REMARKS

Amendments to the Drawings:

Fig. 1 (Prior Art)

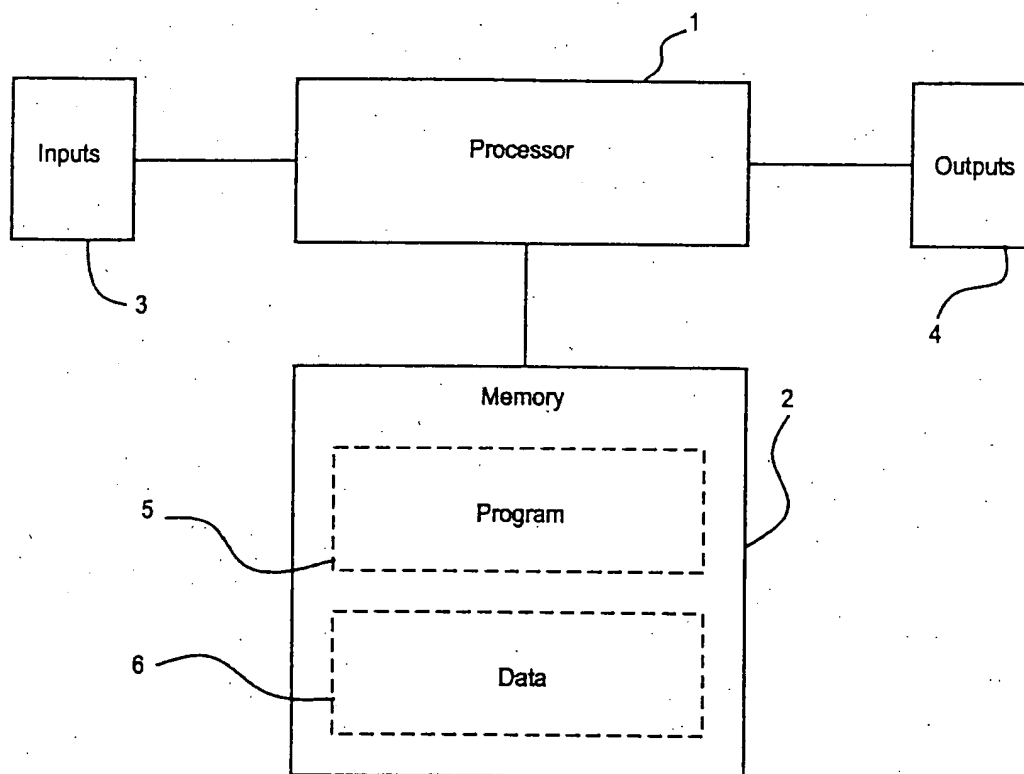
Figure 1 of the drawing has been objected as failing to identify as “Prior Art.”

The corrected drawing sheet has been provided. In the corrected Fig.1, legend of “Prior Art” has been added. Therefore, the objection to the drawing has been overcome and withdrawal of objection is respectfully requested.

The attached sheet of drawing includes changes to Fig.1. This sheet, which includes Fig. 1, replaces the original sheet including Fig. 1. In Fig. 1, legend of "Prior Art" has been added.
